RESOLUTION 1711

A RESOLUTION APPROVING CHANGE ORDER NUMBER TWO, REVISED IN THE AMOUNT BY \$20,100 ON THE CUBBY PARKS IMPROVEMENTS PROJECT.

CHANGE ORDER

Project: Cubby Park Improvements

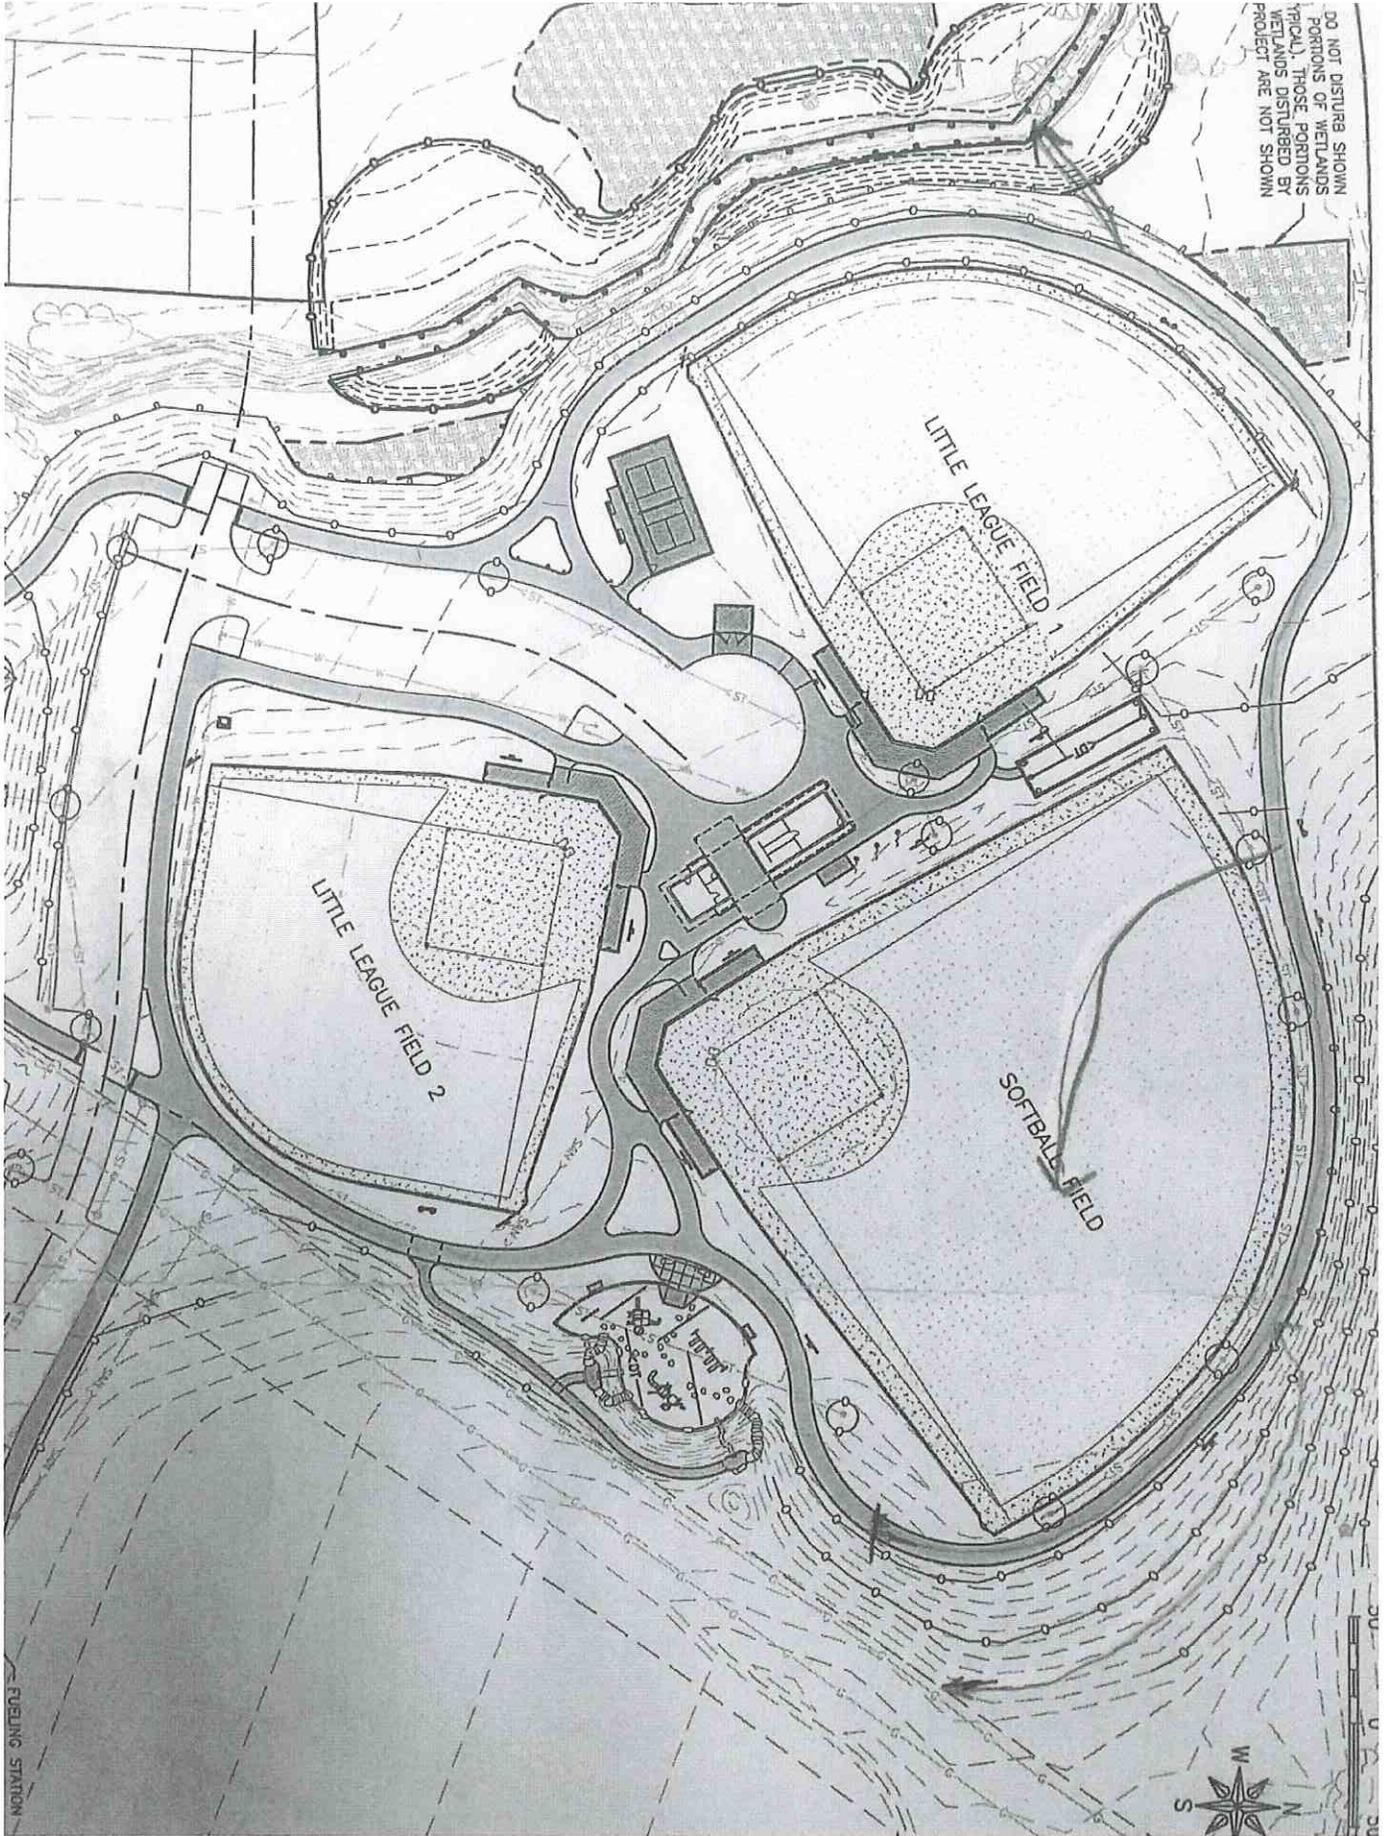
Install 4" drain tile to dewater hillside east of ball fields and provide drainage under the walking trail. Tile shall be 4" HDPE perforated tile bedded in clean stone and outlet to stream west of Little League Field 1.

Ground water is seeping from hillside on the east side of the Softball Field resulting in ponding water and inability to achieve proper compaction. This also gives concern for subsurface drainage of the trail that could cause frost heave issues with the trail. Recommendation is to install the tile to intercept the ground water at a depth to facilitate construction of the park and reduce the chance of frost heave under the trail along the north side of the ball fields.

Justification:

Install 4" drain tile to dewater hillside east of ball fields and provide drainage under the walking trail. Tile shall be 4" HDPE perforated tile bedded in clean stone and outlet to stream west of Little League Field 1.

Ground water is seeping from hillside on the east side of the Softball Field resulting in ponding water and inability to achieve proper compaction.

This also gives concern for subsurface drainage of the trail that could cause frost heave issues with the trail. Recommendation is to install the tile to intercept the ground water at a depth to facilitate construction of the park and reduce the chance of frost heave under the trail along the north side of the ball fields.
